ADDENDUM NO. 1

DATE: December 5, 2017
FROM: City of Grand Junction Purchasing Division
TO: All Offerors
RE: Professional Engineering Services for Parks Raw Water Irrigation Supply Phase I

**DUCK POND PARK LIFT STATION
ELIMINATION AND GRAVITY SEWER CONSTRUCTION
WATER LINE REPLACEMENT PLANS
CANON STREET**

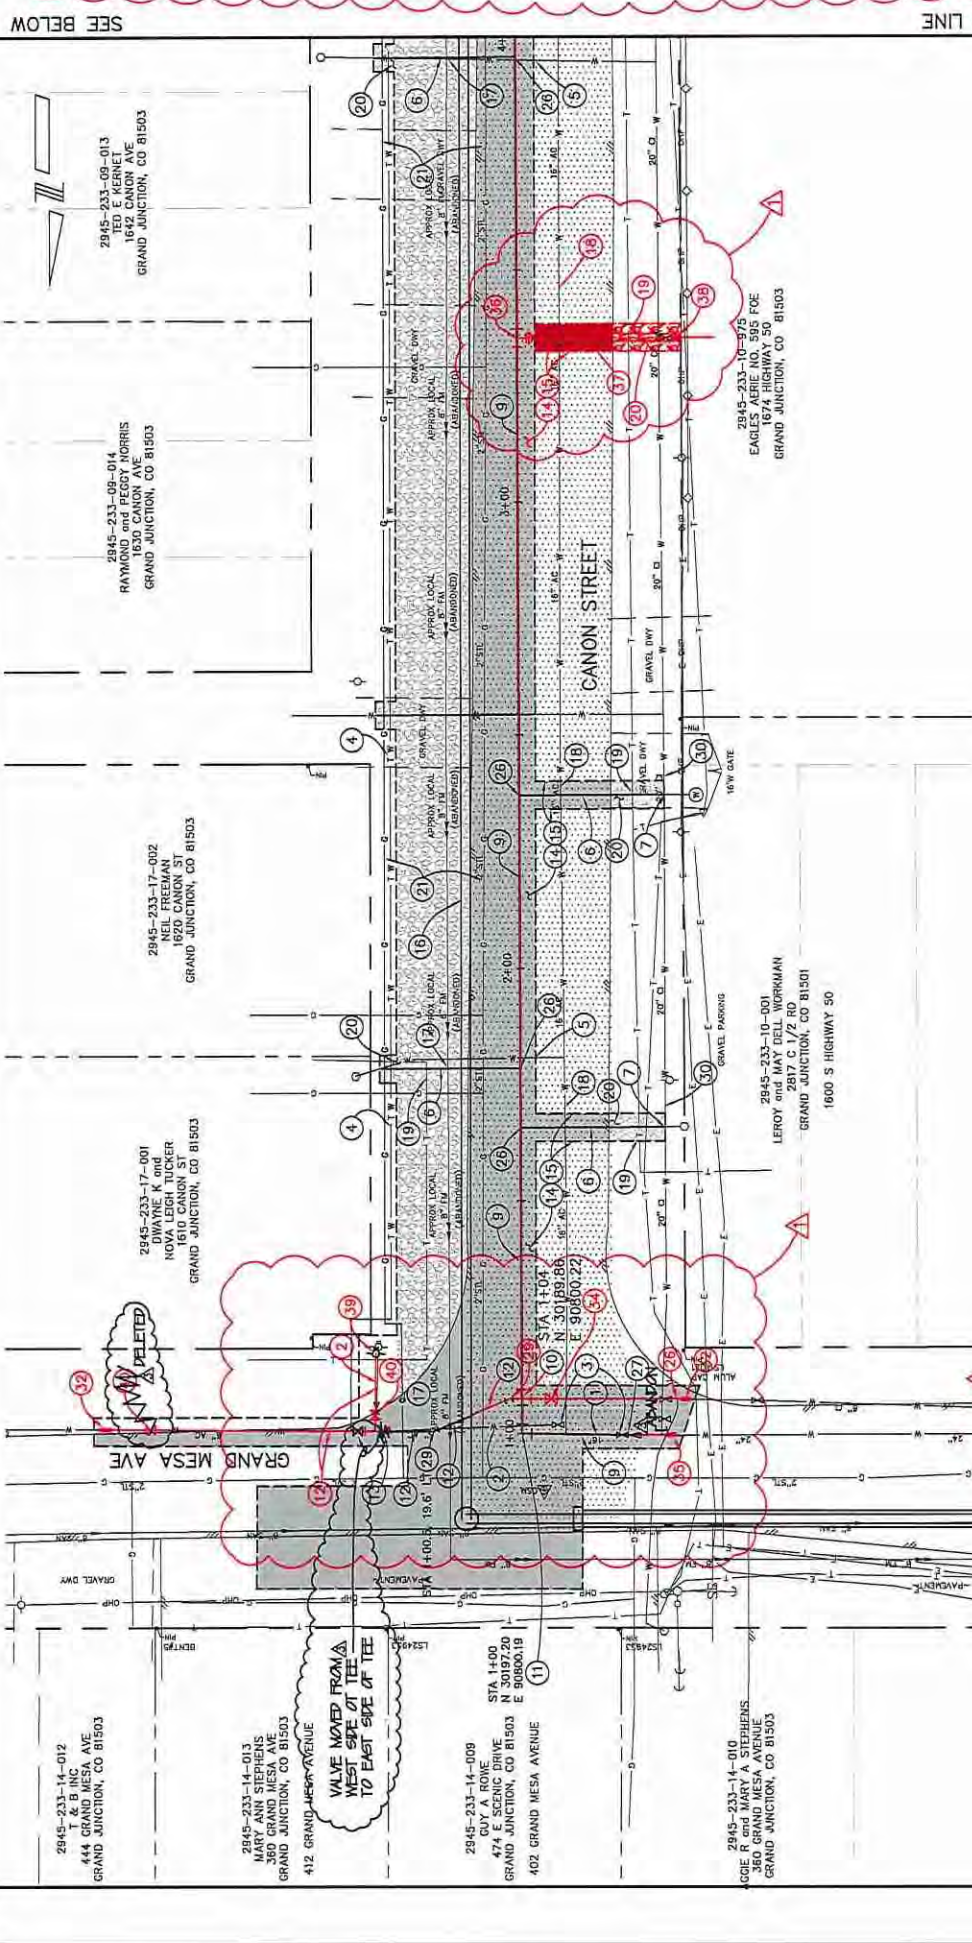
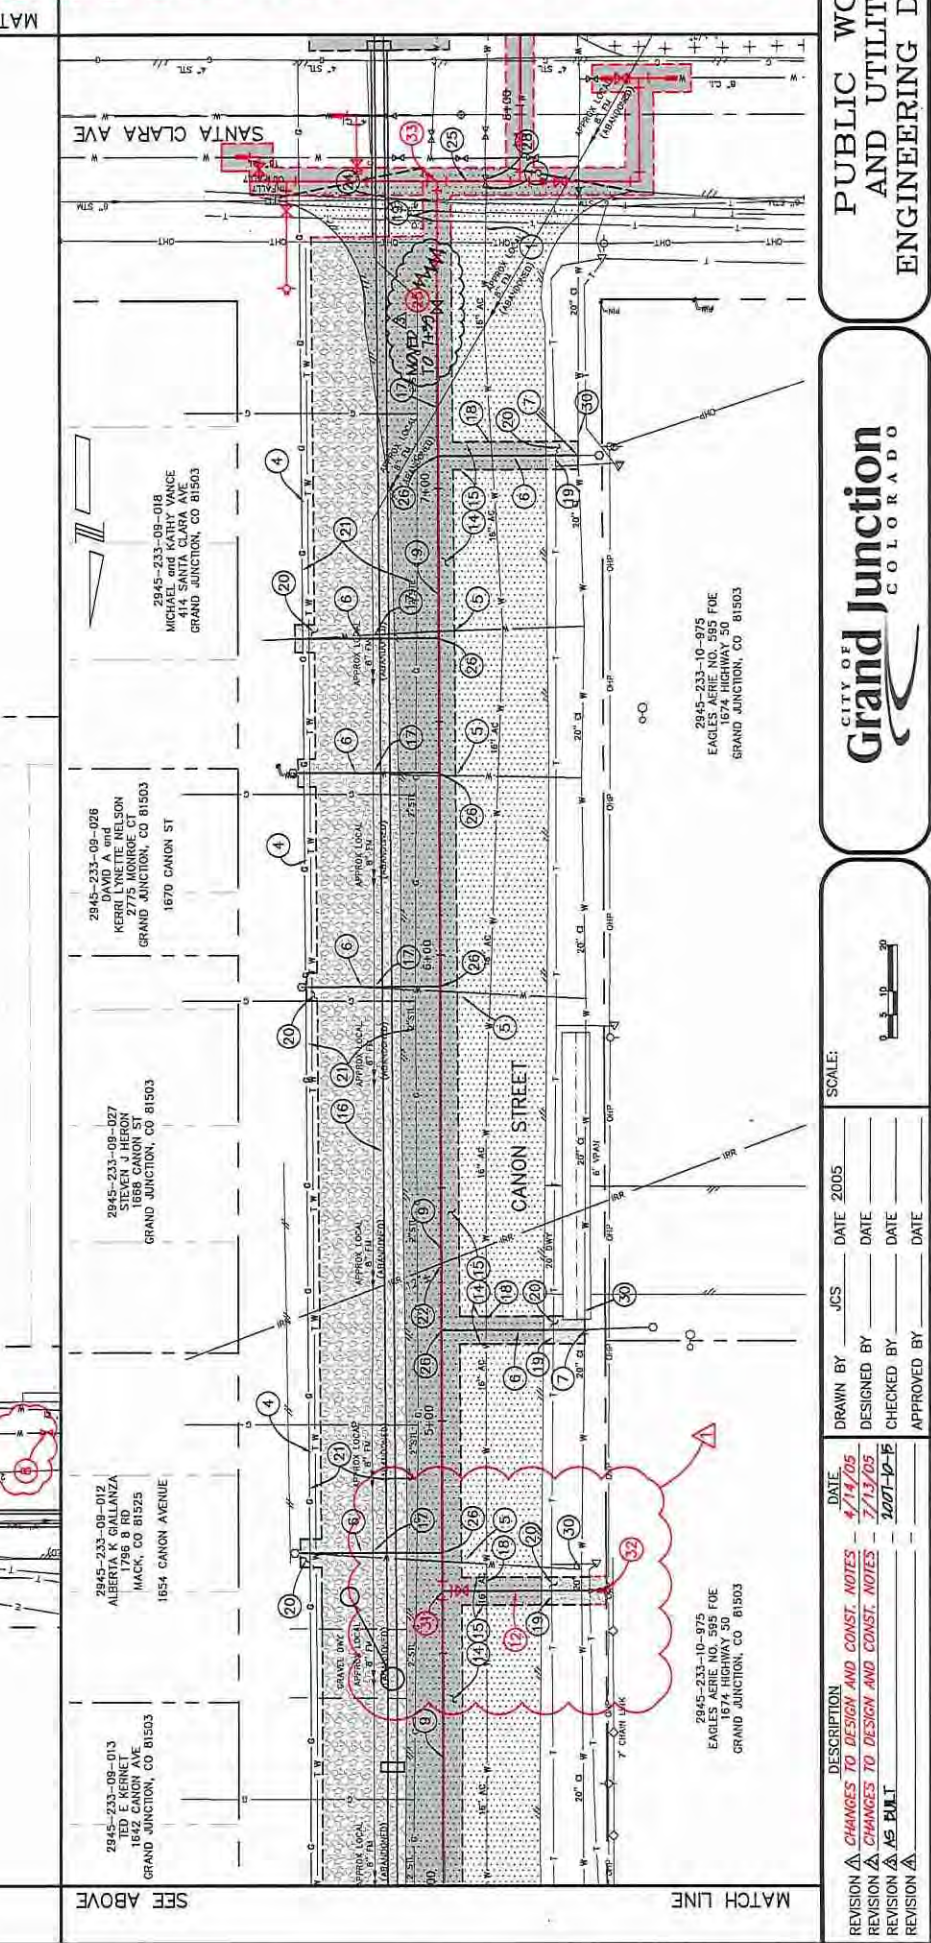
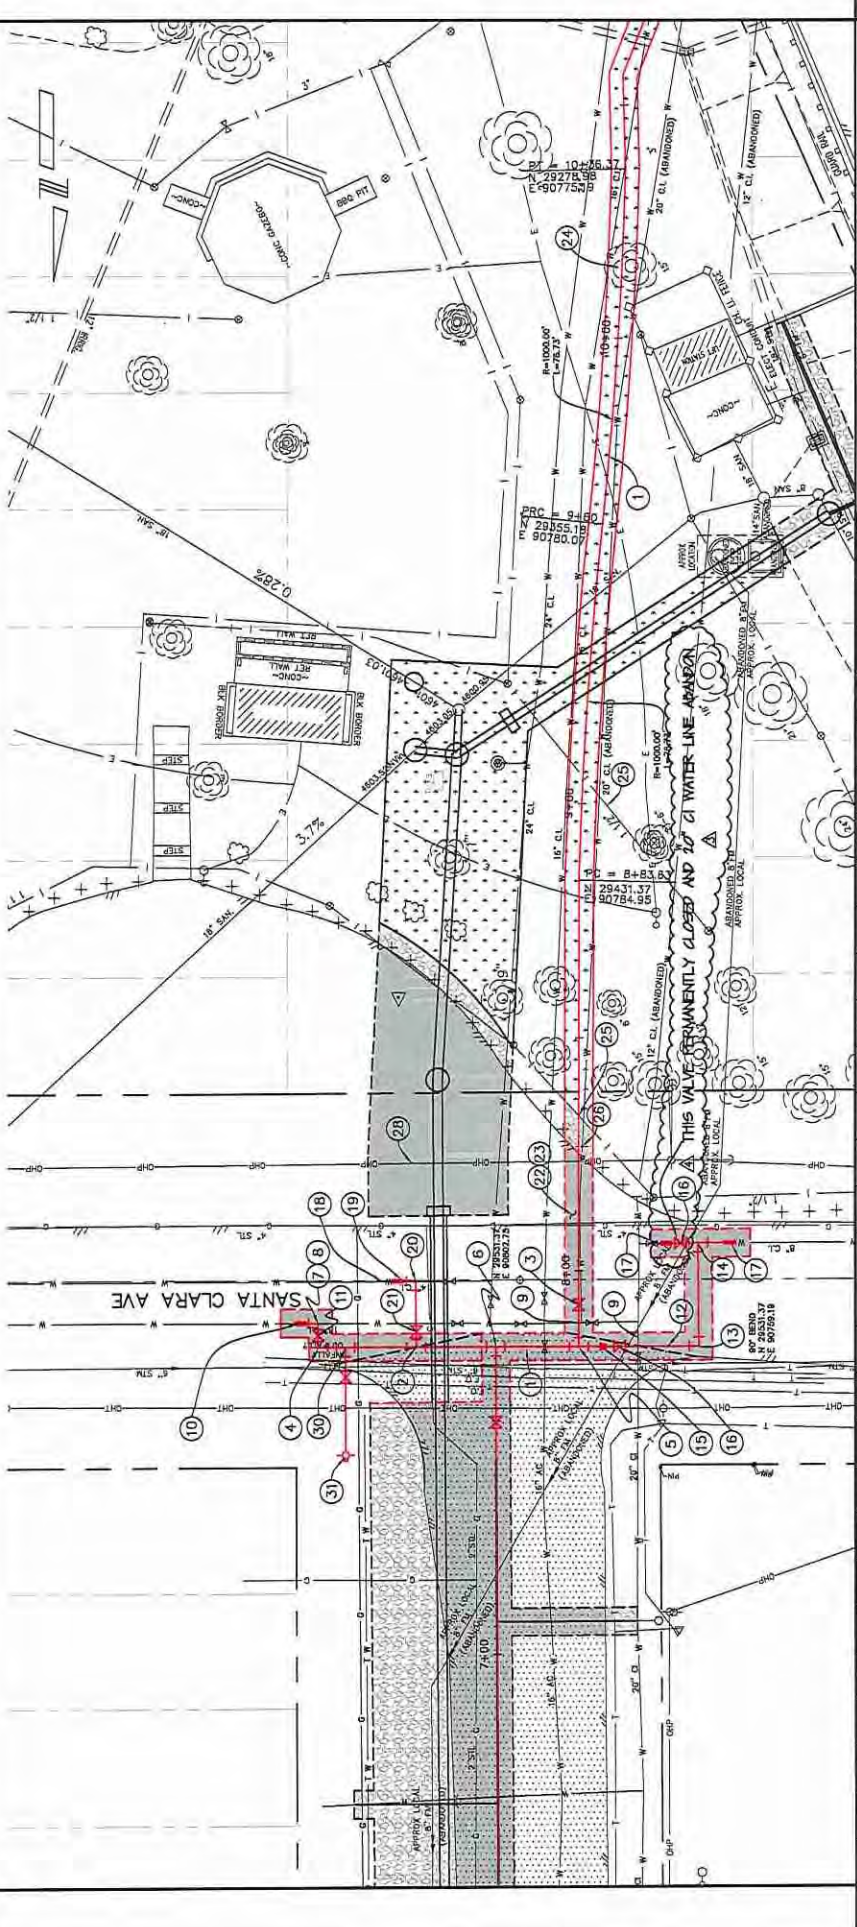
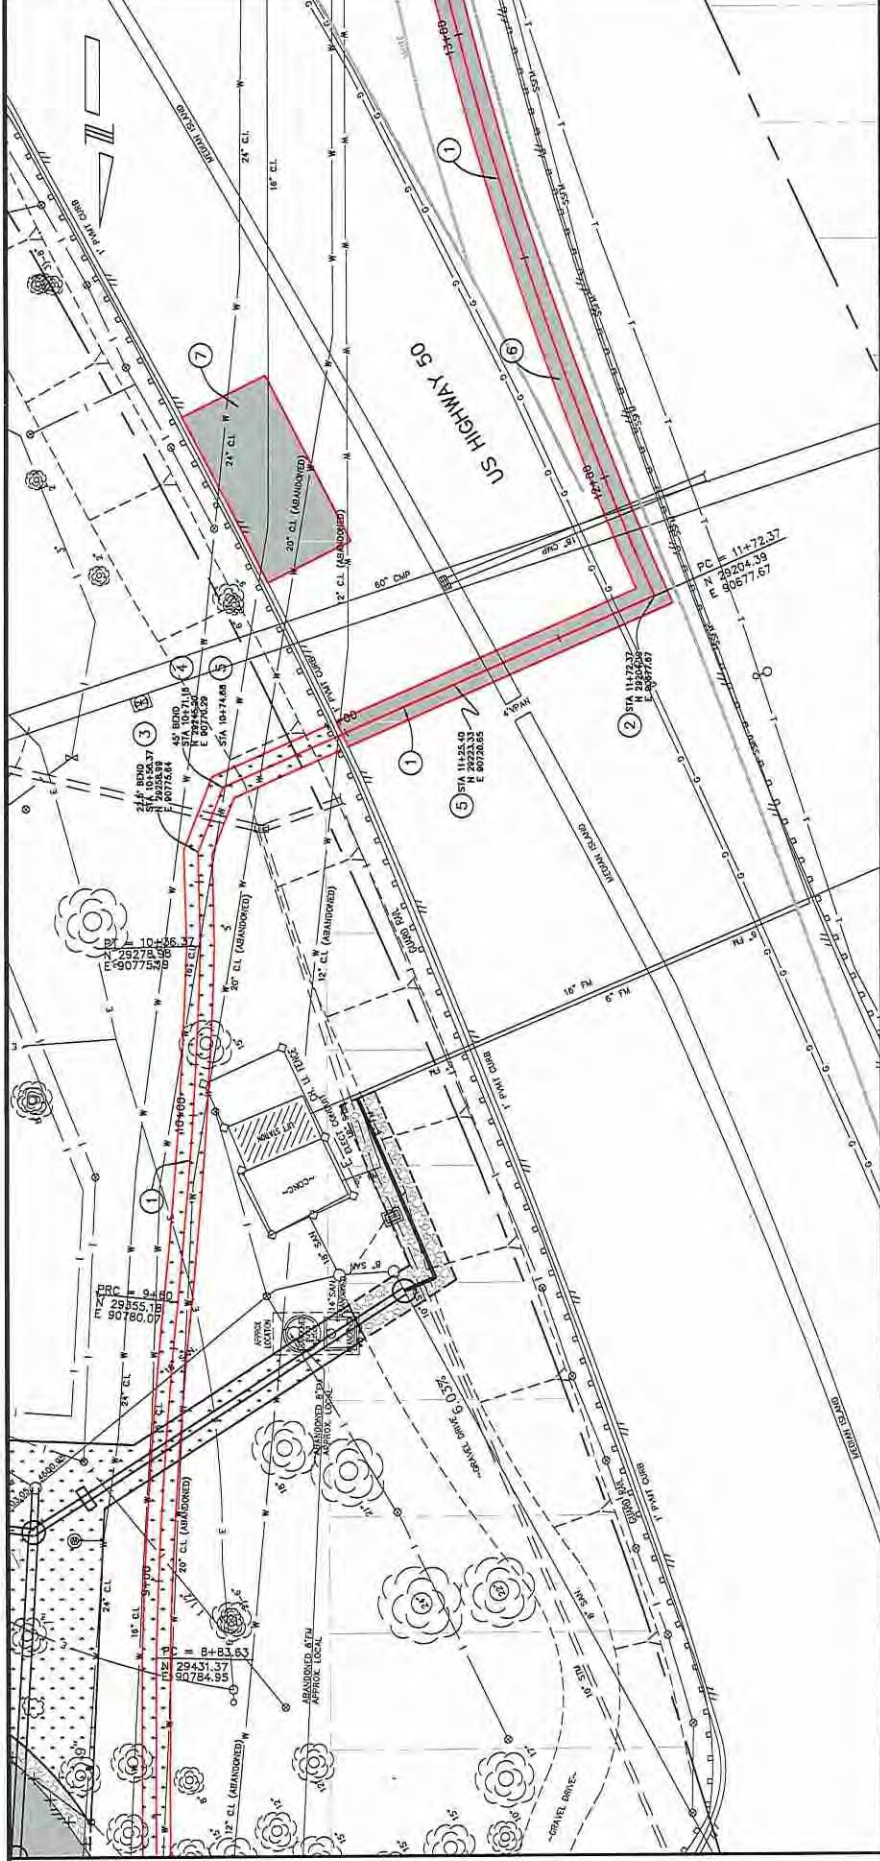
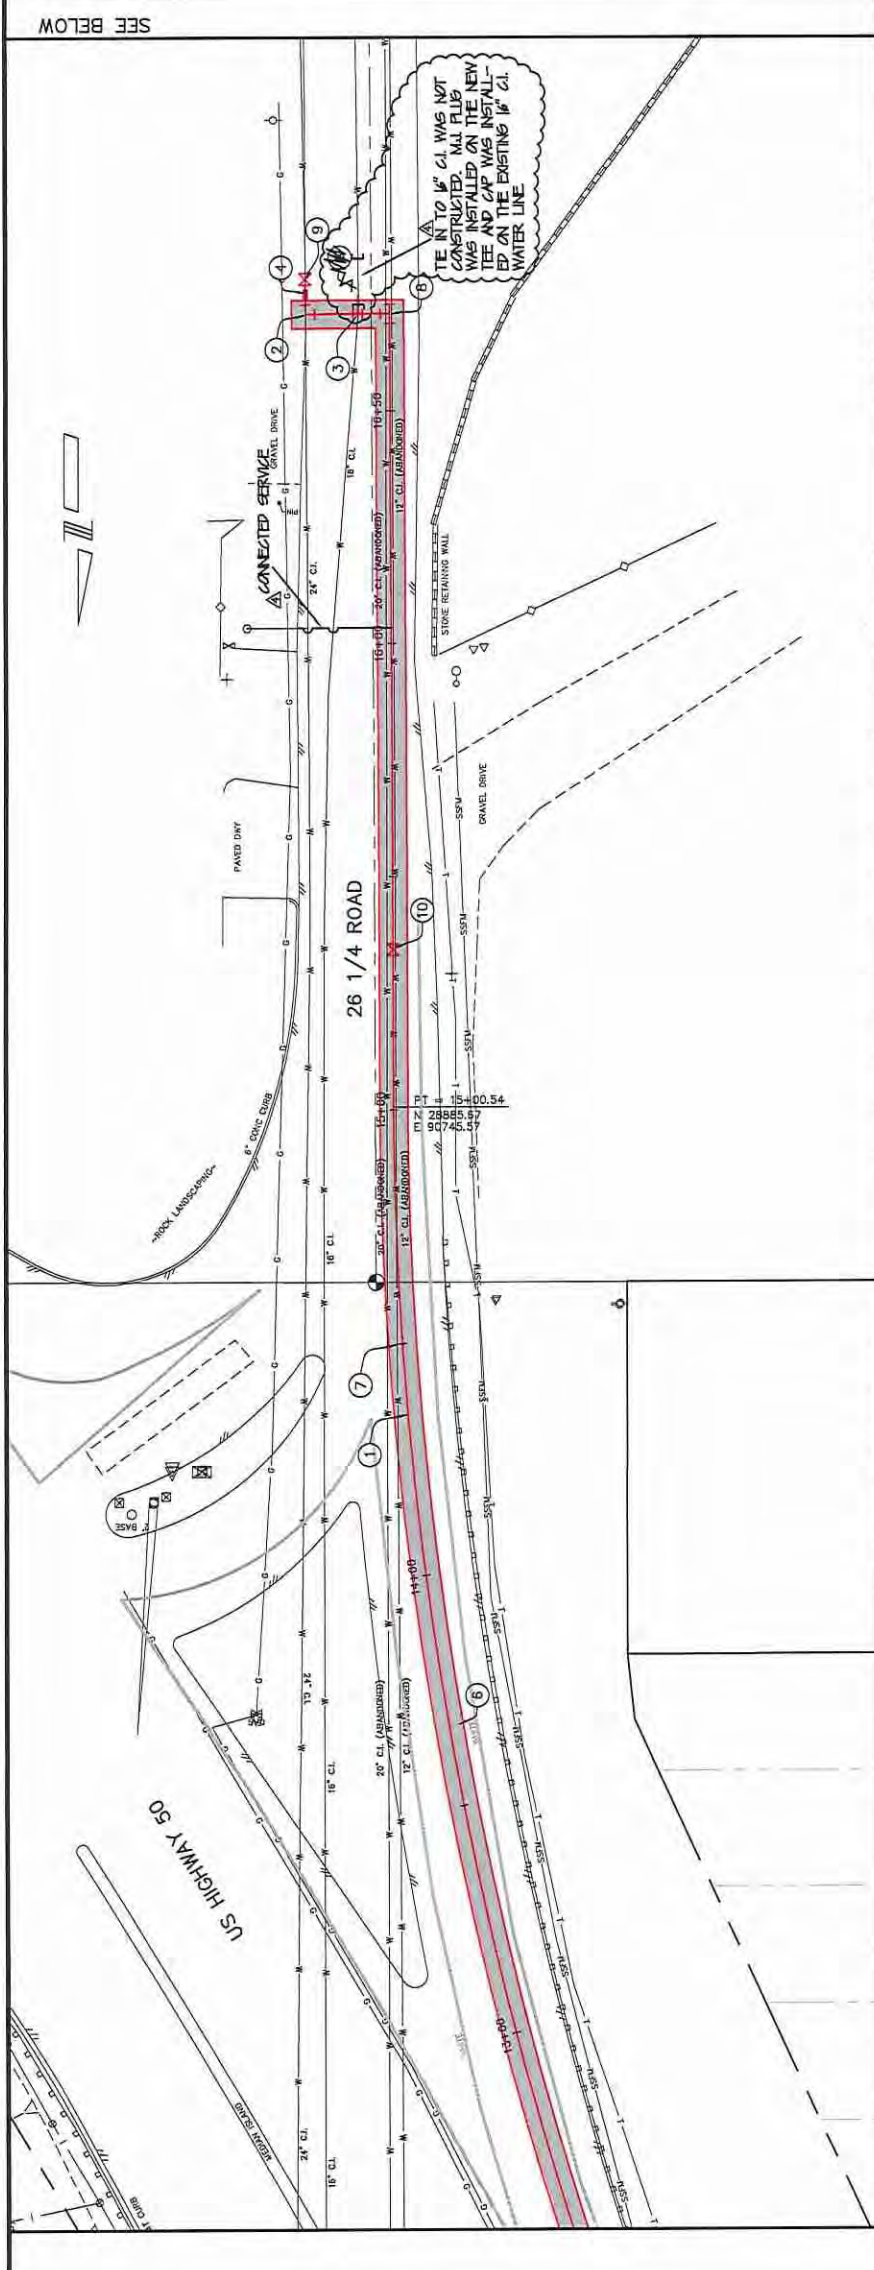
6. Q. Are "rights of ways" addressed for this project?
A. All rights of ways appear to be in order.
7. Q. Can the City provide "as-builts" for the reservoirs?

A. See Attached drawings:
 - a. Settling Basin
 - b. Improvements to Water Supply System Filter Plant Area – Asbuilt 1948
 - c. Duck Pond Park Lift Station Elimination – Water line Replacement Plans - 2005
